1961 Corvette: Chevrolet Product Engineering Technical Information: Spark Plug Electrode Interference With Piston

Subject: Spark Plug Electrode Interference With Piston
Model and Year: 1961 Corvette Models Equipped with Fuel Injection
Source: Chevrolet Service and Mechanical Department - Technical
Information - 1961 Product Data Book
Bulletin Number: Page 3-4 - Section VI - Group 2
Date: 7/8/61

Reworking Piston Dome - 1961 Corvette Models Equipped With Fuel Injection

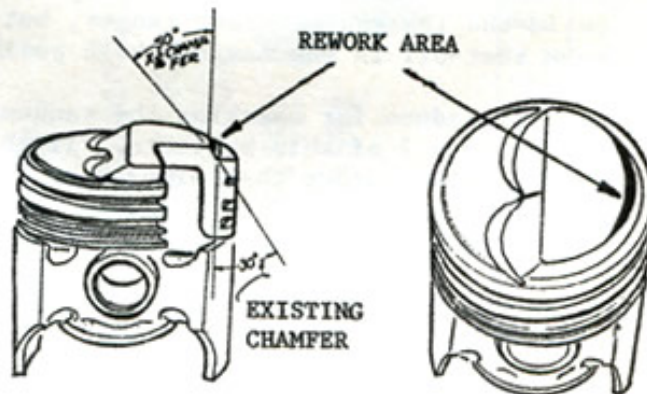
An interference condition between the spark plug ground electrode and piston dome may occur on 1961 Corvette Models equipped with fuel injection. This interference results in a bent electrode which causes insufficient spark plug gap, engine miss and subsequent poor performance.

The condition was corrected in Production effective 5-15-61 (engine date stamp F-0515) by removing 1/16" of the piston dome at the contact area as shown in the following sketch. The size of the area to be removed is approximately 1/16" thick, 1/8" wide and 1-1/2" long machined at a 50° angle. Only the top half of the dome chamfer should be removed with the lower portion remaining at the existing 30° angle.

In the event an 11:0-1 compression ratio engine equipped with fuel injection is being overhauled or if the cylinder heads are removed, each piston dome should be filed or ground off approximately 1/16" to prevent spark plug electrode interference. if only the heads are removed, the pistons should be at TDC and grease applied to the top of the pistons to insure complete remove of filings.

Whenever engine replacement is required, either partial or fitted blocks or if service pistons are being installed, the pistons should be reworked prior to installation.
